**19 TANZA ROAD
HAMPSTEAD HEATH
LONDON
NW3 2UA**

Flood Risk Assessment
March 2026
P02

This Flood Risk Assessment (FRA) has been prepared in direct response to comments provided by the London Borough of Camden following Sustainability Surgery review. The key points raised by the Council and how they have been addressed are set out below.

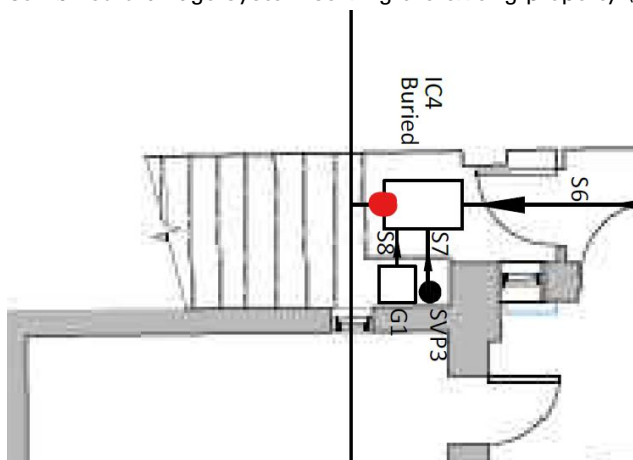
Camden Comment:

Basements with habitable uses (e.g. kitchens/bathrooms) are not normally permitted in flood-prone areas, particularly where they could form a self-contained unit.

To address this, a combination of flood resistance and resilience measures is proposed, including:

- non-return (anti-flood) valves such as the Buffalo Non return valve;

- The anti-flood valve will be located within the last existing manhole on the private combined drainage system serving the exiting property (red dot below)

- a demountable flood barrier at the site entrance (example below); and
